Access Compliance Report

Public Rights-of-Way

Intersection ID: 44932	Main Street: NATHAN_DR	Cross Street: BRUMIT_LN	Location: SE
ADA ID: D41929A04F7F	Ramp Type: PerpDiag	Initial Pass/Fail: Fail	Overall Compliance: No
			Severity Score: 26.25

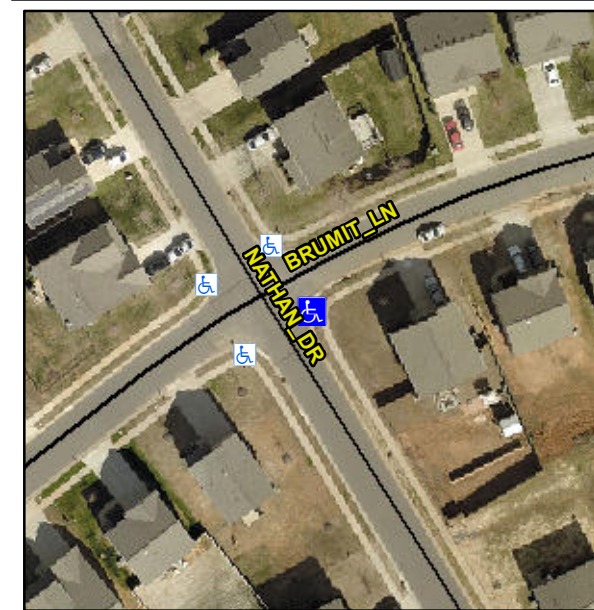
Not Found, R304.2.2, R304.5.3

Compliance	Description	Data	Compliance	Description	Data
N/A	Ramp Length (in)	50.5	No	Ramp Slope (%)	13.1
Yes	Ramp Width (in)	48.0	No	Ramp XSlope (%)	2.2
N/A	Flare Type LT	N/A	N/A	Flare Type RT	N/A
N/A	Flare Slope LT (%)	N/A	N/A	Flare Slope RT (%)	N/A
N/A	Flare Traversable LT?	N/A	N/A	Flare Traversable RT?	N/A
N/A	Landing Length (in)	N/A	N/A	DWS Provided?	N/A
N/A	Landing Width (in)	N/A	N/A	DWS Contrast?	N/A
N/A	Landing Slope (%)	N/A	N/A	DWS Length (in)	N/A
N/A	Landing X Slope (%)	N/A	N/A	DWS Full Width?	N/A
N/A	Landing Curb? (Y/N)	N/A	N/A	DWS Offset (in)	N/A
N/A	Shared Landing?	N/A			
N/A	Gutter Ponding?	N/A	N/A	Gutter Slope (%)	N/A
N/A	Gutter Lip Ht (in)	N/A	N/A	Gutter X Slope (%)	N/A
N/A	Painted X Walk1?	No	N/A	Painted X Walk2?	No
	X Walk 1 Direction	To N		X Walk 2 Direction	To SW
N/A	X Walk 1 Width (in)	N/A	N/A	X Walk 2 Width (in)	N/A
	X Walk 1 Slope (%)	0.5		X Walk 2 Slope (%)	2.0
	X Walk 1 X Slope (%)	1.4		X Walk 2 X Slope (%)	0.2

Remove & Replace Curb Ramp With Two New Directional Ramps or Equivalent.
